# TECHNICAL SERVICE BULLETIN

## 2.7L/3.0L EcoBoost - Oil Pan Leaking

**23-2338**

This bulletin supersedes 22-2181.

Figure 1

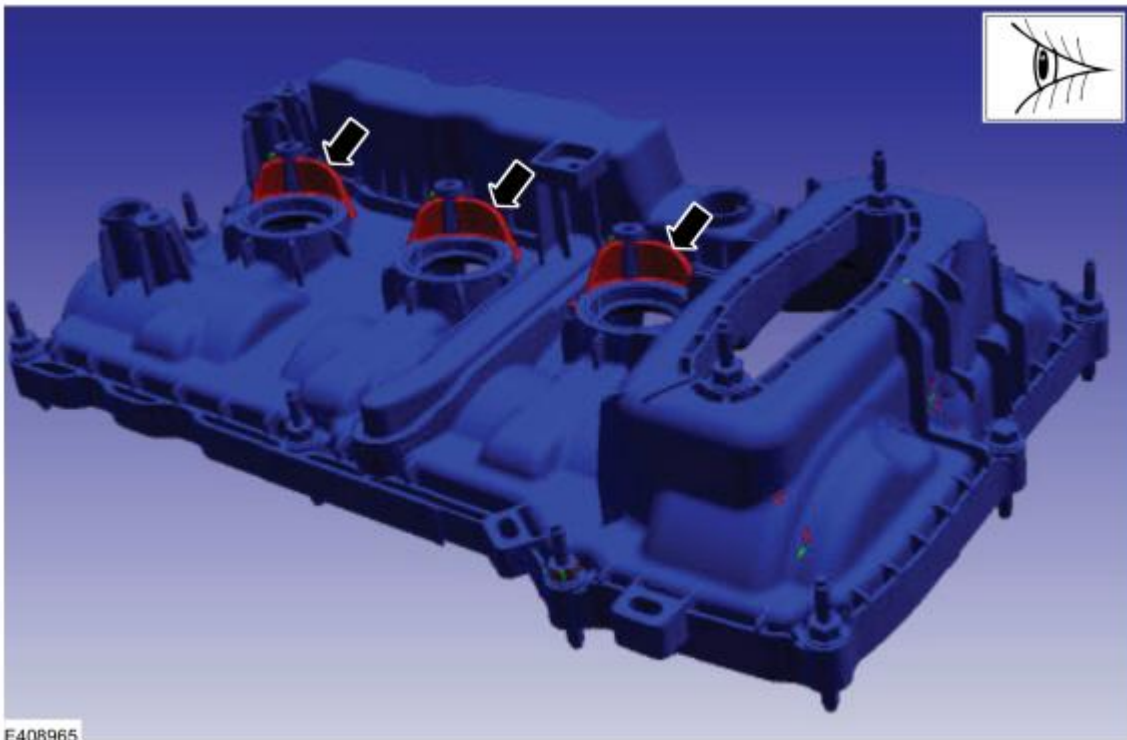
1. Inspect the valve cover design around the ignition coils on both sides. Does the coil location have the extended plastic protective ribbing as shown in red? (Figure 1)

(1). Yes - proceed to Step 3.

(2). No - proceed to Step 2.

2. Replace both valve covers. Refer to Workshop Manual (WSM), Section 303-01, Removal and Installation > Valve Cover LH and Valve Cover RH. Proceed to Step 3.
3. Remove and discard the oil pan and oil pump seal. Refer to WSM, Section 303-01, Removal and Installation > Oil Pan.
4. Clean and prepare the engine sealing surface. Refer to WSM, Section 303-00 General Procedures.
5. Install the new oil pump seal. Refer to WSM, Section 303-01, Removal and Installation > Oil Pan.
6. Apply a 18 mm (0.708 in.) bead of Motorcraft® High Performance Engine RTV Silicone to the oil pan where the front cover-to-cylinder block joint areas contact. (Figure 2)
